SAND2010-6113

# **PAT-1 Safety Analysis Report Addendum Author Responses to Request for Additional Information**

**Docket No. 71-0361**

**Reference: Letter Eric Brenner, U.S. NRC to Maximo Barela, U.S.  
DOE-NNSA, dated March 1, 2010**

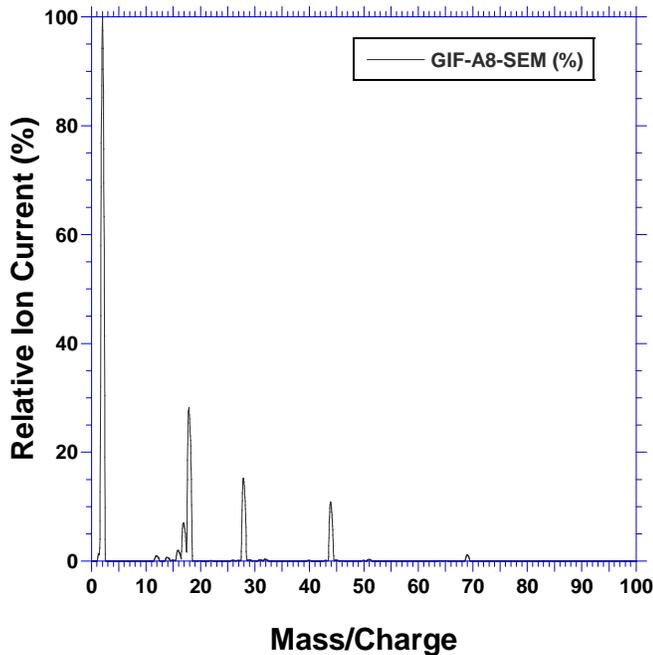
Place restrictions on the operating time of the package to prevent radiation damage to the elastomer seals in the package, and/or change the elastomeric seal materials. Clarify the radiation dose received by the elastomer seal on the TB-1.

The ORNL predicted doses for gamma ( $2.8 \times 10^4$  rad/year) and neutron ( $3.4 \times 10^4$  rem/year) radiation based on a realistic source are less than the  $10^5$  rad cited for no effect in the DuPont technical bulletin and are only marginally above  $10^4$  rad (cited in Bouquet, 3<sup>rd</sup> edition, 1990, (Ref. 1), treating neutrons and gammas equally and exposing for a full year. Note that the 3<sup>rd</sup> edition Bouquet reference only cites "fluorocarbons" and does not provide further details regarding manufacturers' data. In a 1985 article by Bouquet (Ref. 3), he shows in *Figure 4 Summary of Radiation Data for Elastomers. Property: Tensile Strength. Above Average Response Level* that the lowest threshold damage for Viton A® starts at about  $6 \times 10^6$  rads and the 25% change dose is at about  $6 \times 10^7$  rads. In *Figure 6 Summary of Radiation Data for Elastomers. Property: Elongation.*

*Average Response Level for Viton A*, the lowest threshold dose starts at about  $10^7$  rads and the 25% change dose is slightly above  $10^7$  rads. Thus this conservative dose estimate of about  $5 \times 10^4$  rads from the ORNL analysis places the seals under the “little or no effect” dose range for Viton® seals with a full year of contact according to DuPont (also conservative since most shipments should be completed within a month) and at least an order of magnitude below the threshold damage level data for tensile strength and elongation from the Bouquet 1985 article. Furthermore, the amount of time the seals would be typically in close proximity to the contents would make these estimates even closer to a  $1 \times 10^4$  rad cumulative dose for one year.

In conclusion, there is no need to place restrictions for the one year operating time of the package to prevent radiation damage to the elastomer seals because the Viton® A elastomer seals would experience no loss or minor loss in mechanical properties from radiation from the plutonium metal during NCT. Furthermore, the Viton® A elastomer seals in the T-Ampoule and SC-1 and SC-2 sample containers are not containment boundary components and do not provide a safety function but serve to maintain product quality.

### Request for Additional Information: 2-8

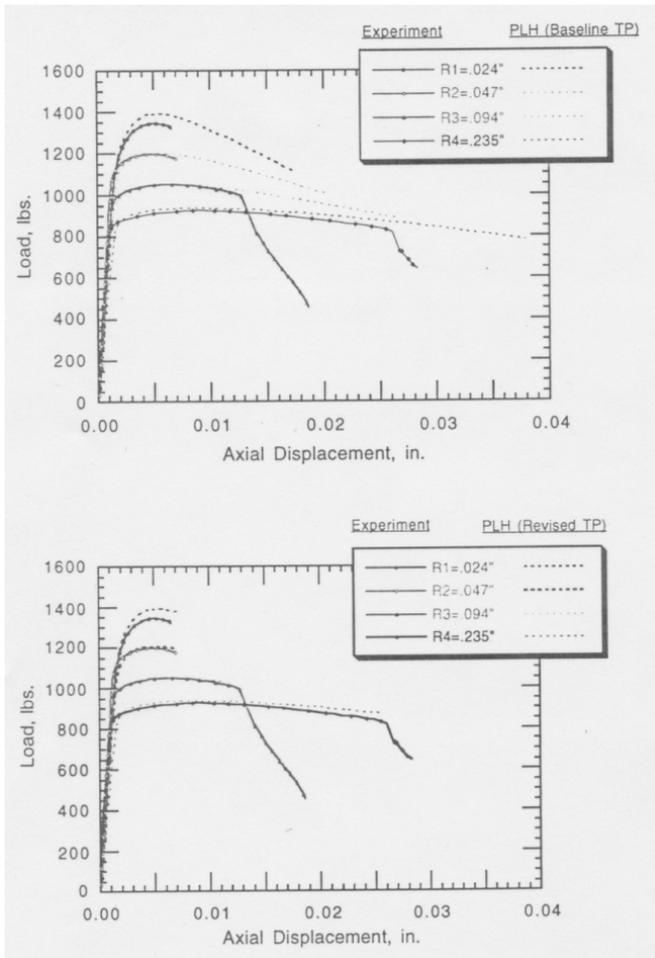
Describe in detail how the critical tearing parameter is determined and its relationship to the locus in equivalent plastic strain – stress triaxiality space.

The applicant derived the critical tearing parameter based on a finite element simulation of a uniaxial tension test. Given the multiple references to stress triaxiality, staff is unclear whether the formulation and use of a 1D acceptance criterion in conjunction with a 3D stress strain state locus is a consistent and relevant methodology.

First, this isn't a 1D acceptance criterion at all; it has been proven to work exceedingly well for many 3D stress states (in fact the addition of the 4<sup>th</sup> power over Brozzo's similar original failure criterion in 1975 was to better match highly notched, highly 3D specimens. See the figure below, where the upper graph compares notched tensile tests with FEA using the Brozzo failure criterion, and the lower graph shows a much better match using the updated Tearing Parameter (TP) [reference: Dawson, D. B., Antoun, B. R., and Mosher, D. A., "Fracture of Weapons Materials," Memo report to distribution, page 18, October 5, 1998, Sandia National Laboratories]). Even the uniaxial tension test used to determine the critical TP value is actually a 3D stress state (or at least 2D axisymmetric) due to the necking that occurs up to failure.

The TP equation needs to be slightly modified in SAR; (see below). The TP almost appears to have stress triaxiality within its definition because it (the integral) only accumulates value when the ratio inside the Heaviside brackets (tends to mimic stress triaxiality) is positive, but it also accumulates value (damage) much more quickly when the Heaviside ratio (mimicking stress triaxiality) is highly positive, as in near-perfect hydrostatic tension. But stress triaxiality is the mean stress (average of 3 principal stresses) divided by the von Mises stress, whereas TP has the difference of the maximum principal stress and the mean stress in the denominator.

FIG. 3.0219 EFFECT OF STRAIN RATE ON TENSILE PROPERTIES OF ANNEALED AND AGED BAR (13, p. 9)

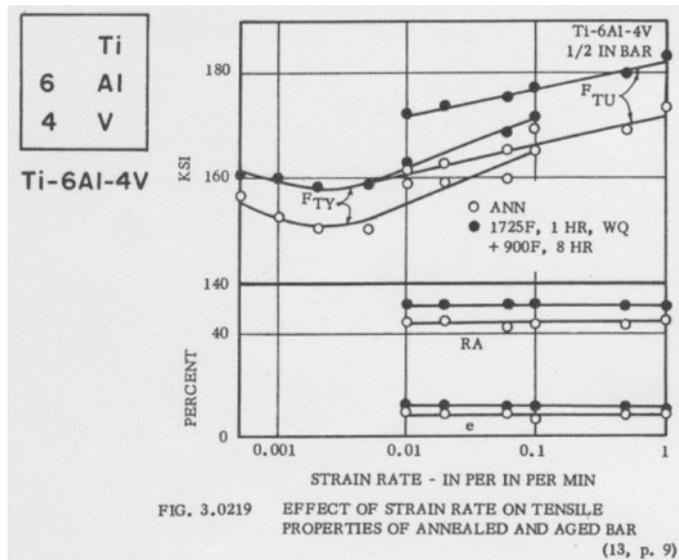
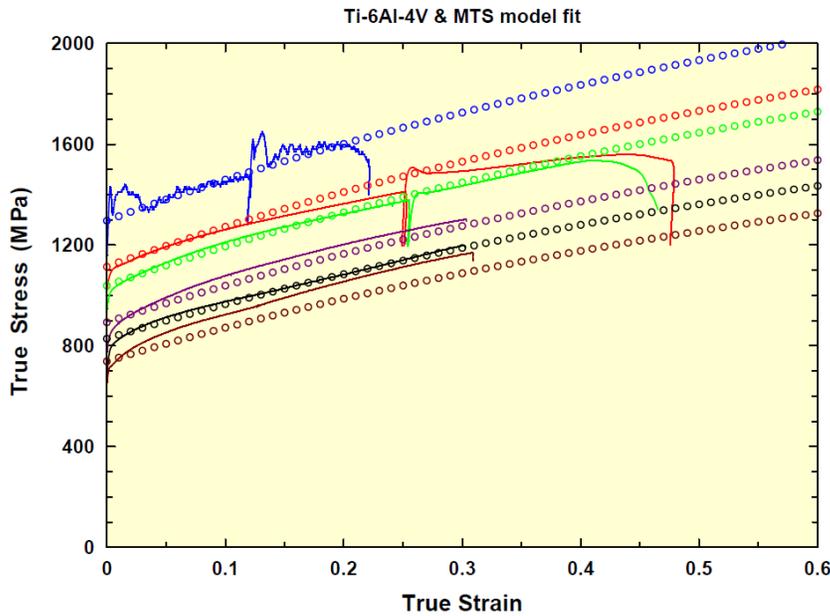
Given that this locus was developed at speeds of 200 ft/s rather than 422 ft/s, the applicant should provide a velocity range for which the locus is applicable. Alternatively, the applicant should provide a thorough explanation as to why the locus developed at lower velocity is acceptable to use outside of the regulatory framework requiring a velocity of 422 ft/s.

Some materials have high strain rate dependencies, but Ti-6Al-4V was chosen for the T-Ampoule eutectic barrier material due not only to its high strength, light weight, good ductility, and excellent corrosion resistance, but also because of its low strain rate sensitivity. For example, the material is commonly used in the aerospace industry for jet engine fan blades, in part because of its resistance to failure during bird strikes. At lower strain rates (0 to 1 inverse seconds), the yield and ultimate stresses harden slightly, but ductility is unaffected (reference graph from: “Department of Defense Aerospace Structural Metals Handbook”, code 3707, page 12, March 1965), as shown below.

Los Alamos National Laboratories compiled historical data on higher strain rate testing of Ti-6Al-4V (Reference: Strain Rate Sensitivity Data Used in LANL's Ti-6Al-4V MTS Strength Model, e-mail from George T. Gray (Los Alamos National Labs) to David C. Harding (Sandia National Laboratories), February 19, 2010) and it shows only relatively modest increases in strength and decreases in ductility (especially relative to other

ductile metals, which are typically much more strain rate sensitive) up to 1340 /sec strain rates (see graph below, the solid curves).
